BCA Assessment Report

Billbergia - 40 Walker Street, Rhodes

Prepared for Billbergia Developments Pty Ltd

11 November 2010

3. Clause C2.6 – Vertical Separation of Openings in External Walls

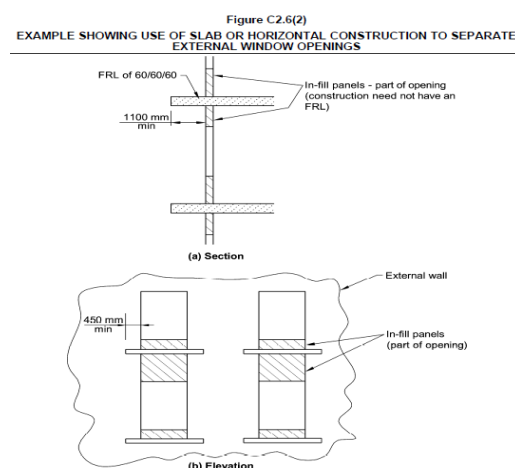
As only parts of the building are proposed to be sprinkler protected due to a potential performance based solution for the deletion of sprinklers to the low rise towers, the low rise towers will be required to comply with the spandrel separation requirements of the BCA.

If the deletion of sprinklers to the low rise buildings is approved, a performance based solution will also be required to address that the whole of the building is not sprinkler protected and that spandrels are not required to the high rise towers.

Spandrel separation is required to be provided to the external openings of the building. In this regard, any part of a window or other opening in an external wall that is above another opening in the storey next below and its vertical projection falls no further than 450mm outside the lower opening (measured horizontally), the opening must be separated by a spandrel that is less than 900mm in height and extends not less than 600mm above the upper surface of the intervening floor.

Note: Where balconies provide horizontal spandrels, they are required to provide 450mm protection on either side of an opening in accordance with the figure detailed below.
